Appendix N-3

UXR Responses to Comments - Transportation

DATE: July 10, 2023
TO: Nicole N. Cobleigh, Dudek
FROM: Charlene So and Alex So, Urban Crossroads
JOB NO: 14064-01 RTC

WEST CAMPUS UPPER PLATEAU RESPONSE TO COMMENTS

Figure A-7.1-1 Proposed Project Circulation Plan

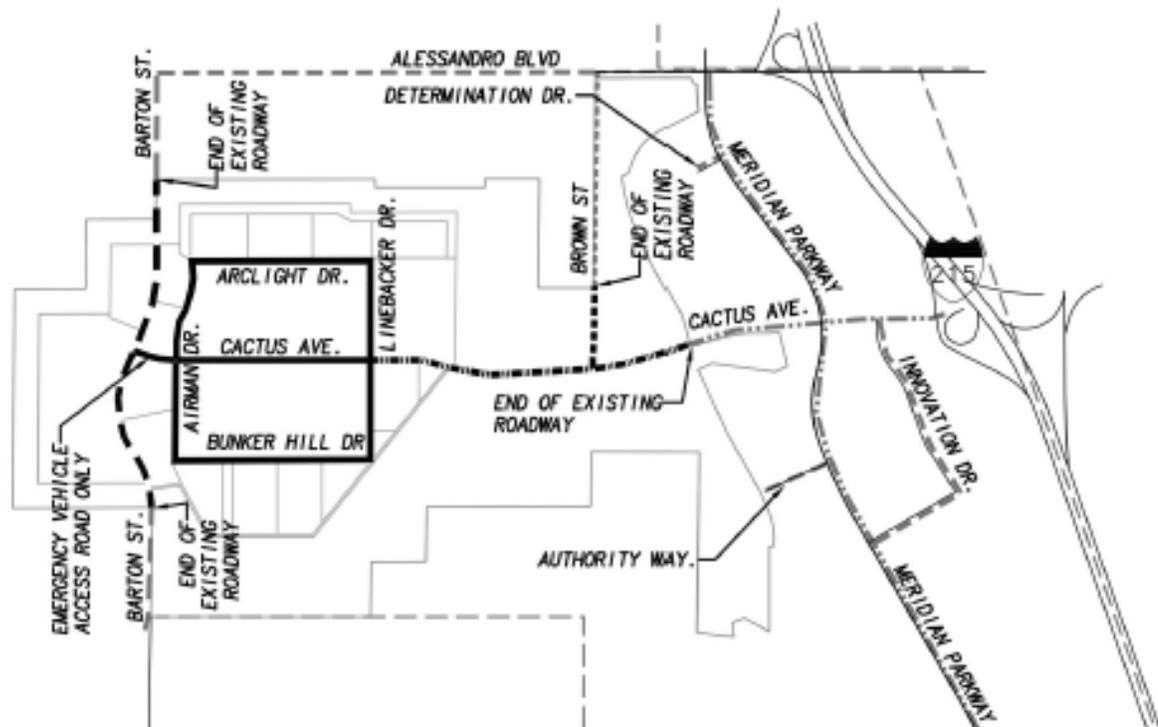
Will there project provide any physical improvements to restrict trucks from accessing Alessandro Blvd. and travel west? If yes, can you provide a copy of the conditions of approval that will requires its implementation?

The Project is designed to funnel trucks away from neighborhoods and onto approved truck routes. The parcels within the Campus Development can only be accessed via Cactus Avenue. Leaving the Campus Development, Brown Street would be the first cross-street. The Cactus Avenue ramps onto southbound I-215 and northbound I-215 are approximately ¼ miles and ½ miles, respectively, directly past the next cross-street, Meridian Parkway. See Figure A-7.1-1, below.

Figure 1. Map of project area with a 15-mile buffer for the regional transportation analysis that shows existing warehouses in orange and planned/approved warehouse plans in red. Projects that are approximately 5 million square feet or larger are labeled.

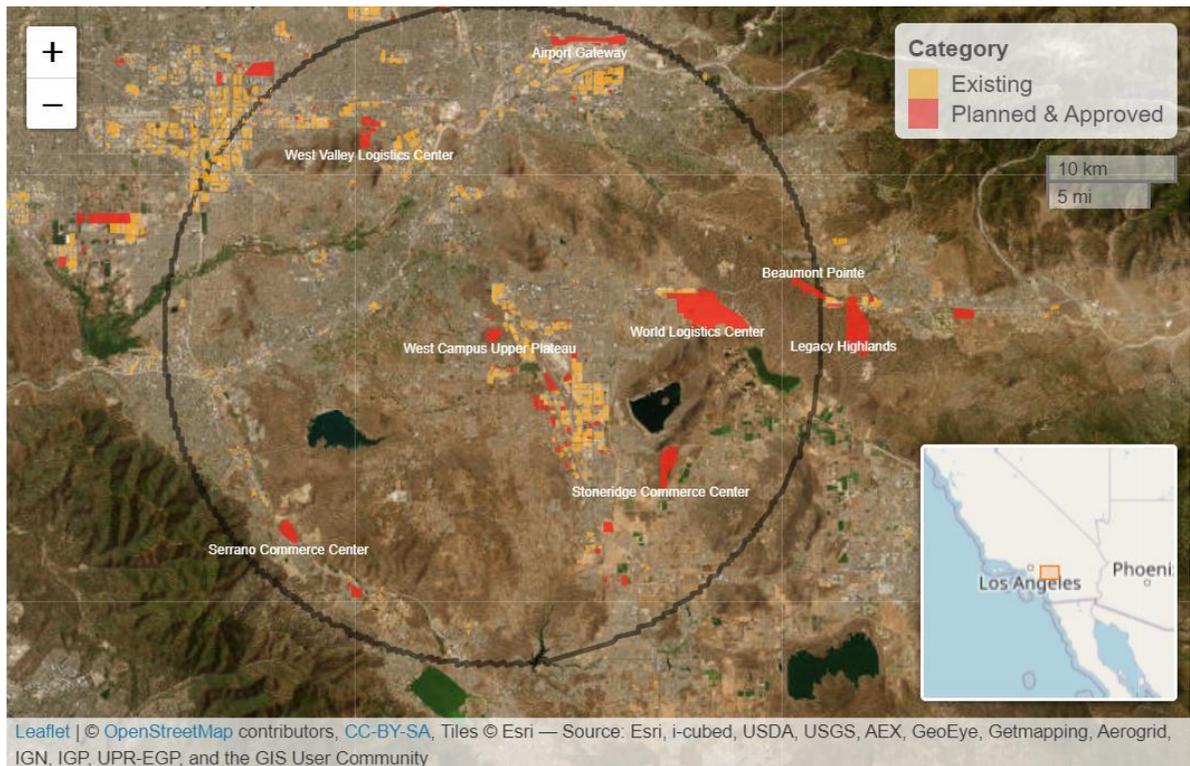
- 2) *the March JPA justify its failure to consult with CalTrans on a project that will add significant traffic to the 215 Freeway (~20,000 passenger trips, ~2,000 truck trips, per Appendix N, Exhibits 4 & 5) and is less than 1 mile from the 215 freeway, in contravention of WRCOG and County of Riverside guidance? "For projects within one mile of a state highway, or any project that may add traffic on the state highway, the Engineer shall also coordinate with Caltrans." (WRCOG 2020, County of Riverside 2020)⁴*

- 3) *the March JPA justify its exclusion of more than 60 million square feet of planned and approve new warehouses that are within the 15-mile service area from the cumulative impacts project list.*

1) The 15-mile service area identified by the commenter signifies the bounds of the region utilized by the 2022 VMT Analysis to determine if the addition of the Project's retail component would result in a net increase in total VMT for that region. As explained in the 2022 VMT Analysis, a 15-mile service area is a conservatively estimated distance from the Project as the retail component is not anticipated as a regional shopping destination, but instead is anticipated to serve the surrounding communities of Riverside, Moreno Valley, Perris, etc. Refer to Response I-74.2, above, regarding 2022 Traffic Analysis for I-215 and the 215/60 corridor.

2) Refer to Response I-74.2, above, regarding 2022 Traffic Analysis for I-215 and the 215/60 corridor.

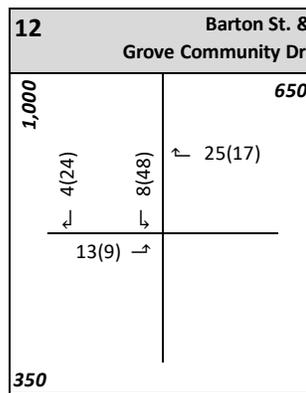
- 1) Justify existing project traffic counts that have average daily traffic volumes greater than peak daily traffic volumes times 24 hours.
- 2) Justify modeling four-way traffic at a three-way intersection
- 3) Given that the modeling has basic input and non-physical entries in the results section, how can it credibly project the traffic volumes in the future given that the basic results are unreliable?
- 4) Please revise traffic results to identify why intersections were incorrectly modeled mathematically and physically

As noted by the commenter, Exhibit 4-3 appears to show the incorrect lane configuration and volume for Intersection #12 – Barton St. & Grove Community Dr. Below is an image of the correct intersection.

Exhibit 4-3 of the 2022 Traffic Analysis has been revised to reflect the corrected intersection diagram for Intersection #12. The analysis used the correct lane configuration and no further revisions to the 2022 Traffic Analysis are required.

March JPA General Plan Land Use Map - February 2023.

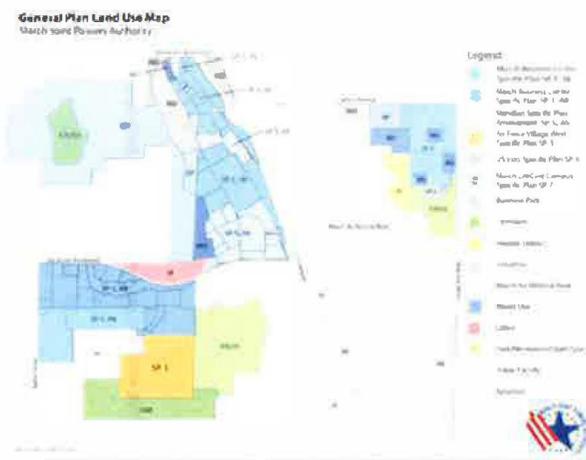
Our best estimate is that the March JPA has an existing warehouse footprint (i.e., parcel size)¹ of approximately 23 million square feet, with an estimate square footage of approximately 12 million square feet. Multiple warehouse and industrial facilities within the March JPA Meridian Specific Plan SP-5, AS, Specific Plan SP-1, A6, and aviation facilities associated with commercial cargo operations and the proposed Meridian D-1 Aviation Gateway are left off the March JPA planning area cumulative impacts list. These are clearly visible in the March JPA General Plan Land Use Map.

The 2022 Traffic Analysis includes existing development, including warehouses, as part of the existing conditions baseline. Refer to Response I-74.2, above, for an explanation of the selection of cumulative projects. All development projects, including the existing surrounding warehouse developments, are included in the baseline traffic counts if the developments are built and operational at the time traffic counts were collected. Future known pending/approved development projects are included in the cumulative traffic analysis for future conditions. The cumulative analysis includes known cumulative projects within a 5-mile radius of the proposed Project site.

Figure 1- Map of project area, surrounded by a 1-mile buffer. Warehouse colors indicate the jurisdiction responsible for land-use authority, while the fill indicates an existing (white) or planned/approved (gray) warehouse project.

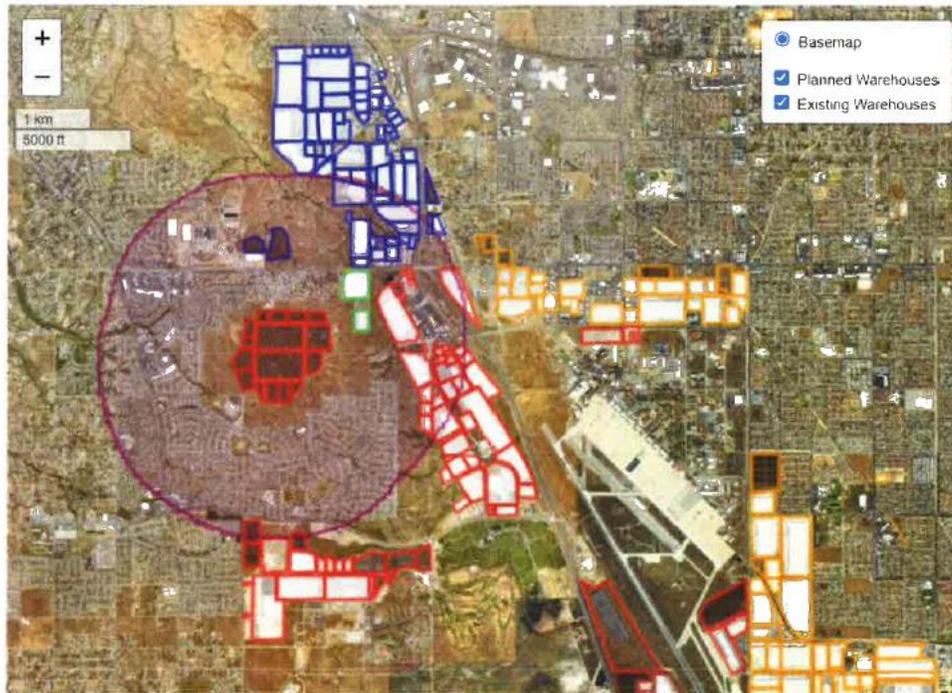
However, it is also clear that the 'immediate vicinity' of the Meridian West Campus Upper Plateau has far more warehouses than the March JPA planning area includes. Therefore, we request that all 'Immediate Vicinity' analyses include all warehouses and designated truck routes located within 1-mile of project specific plan area as shown in Figure 1. Thus, we request that all warehouses and truck routes within this 1-mile boundary be explicitly included in all construction phase and operational phase analyses that fit the 'Immediate Vicinity' geographic scope.

Figure 2 - 10-mile regional buffer region with warehouses (existing and planned/approved) overlaid. Existing warehouses have a white fill, while approved/planned warehouse areas are filled in gray.

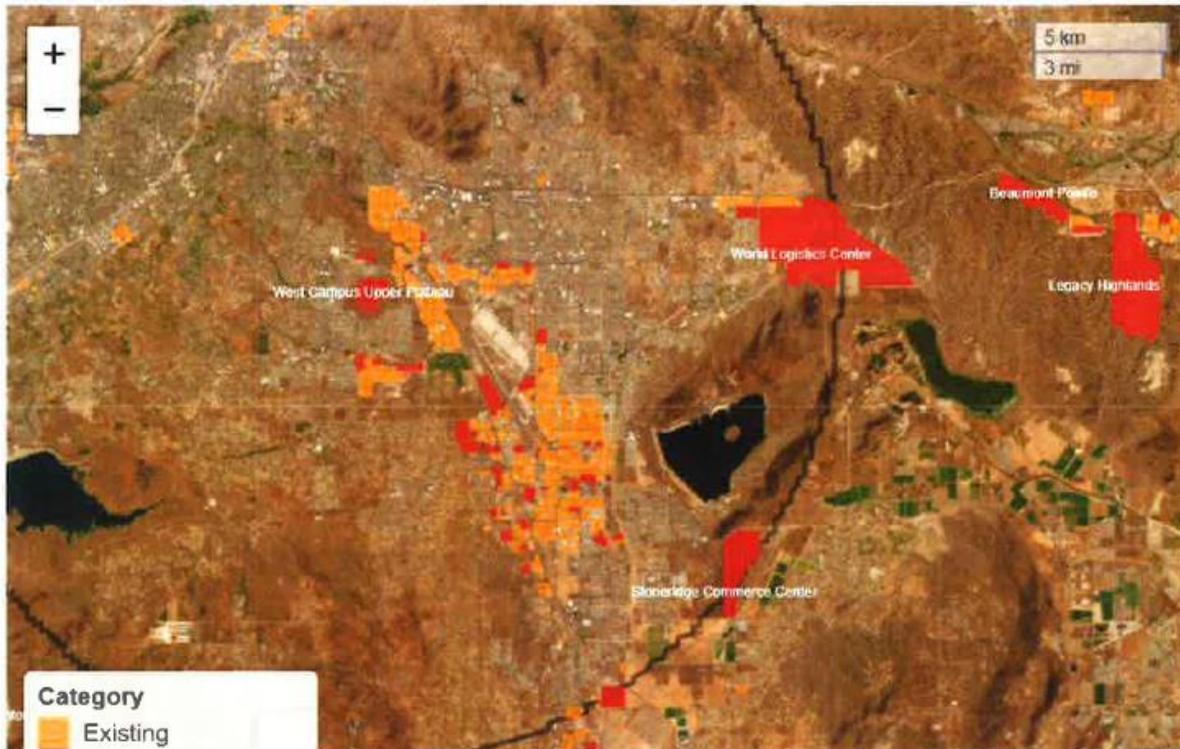
Figure 2 helpfully identifies a 10-mile buffer region around the project boundary, although I only include Riverside County warehouses to focus on the 215/60 corridor impacts as the primary transportation and land-use bottle-neck is within the Riverside county portion.

The existing regional warehouse footprint of warehouses is approximately 280 million square feet. The planned and approved warehouse footprint includes another 200 million plus square feet of land, nearly doubling the existing footprint.

Refer to Response I-74.2, above, for an explanation of the selection process for cumulative projects. The traffic generated by the existing development projects are already accounted for in the existing baseline traffic counts. See also Response I-834.4, above.

Figure 3 - Existing and planned/approved warehouse development in a 15-mile ring (black circle) around the West Campus Project.

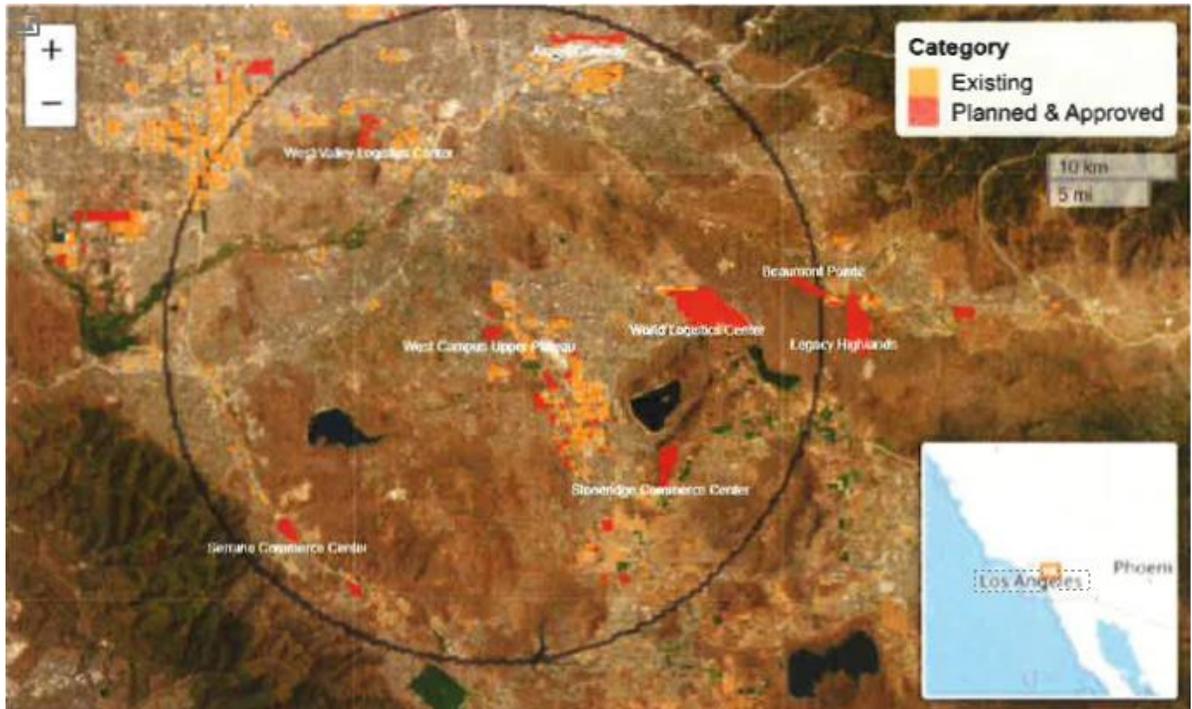
I leave you with one last map showing the 15-mile regional buffer of warehouses within our region. It includes some of the other mega-projects just at or beyond the regional boundary defined in the Transportation analysis section. Figure 3 shows the whole Inland Empire, a 15-mile buffer boundary around the project, and a few labeled mega-warehouse complexes that have been approved or are in planning stages ranging from NOP to draft EIR. Key complexes not mentioned yet include the Serrano Commerce Center, West Valley Logistics Center, Speedway Commerce Center, Airport Gateway, Bloomington Business Park, South Ontario Logistics Center, Merrill Commerce Center, and the Renaissance Ranch Commerce Center, and the South Perris Industrial Center.

To put this in proper perspective, it needs to be explicitly addressed in the EIR and these project lists are 100% consistent with the geographic scope listed in Section 4.0. Please add these projects and do a truly comprehensive analysis of the regional impacts of warehouse growth.
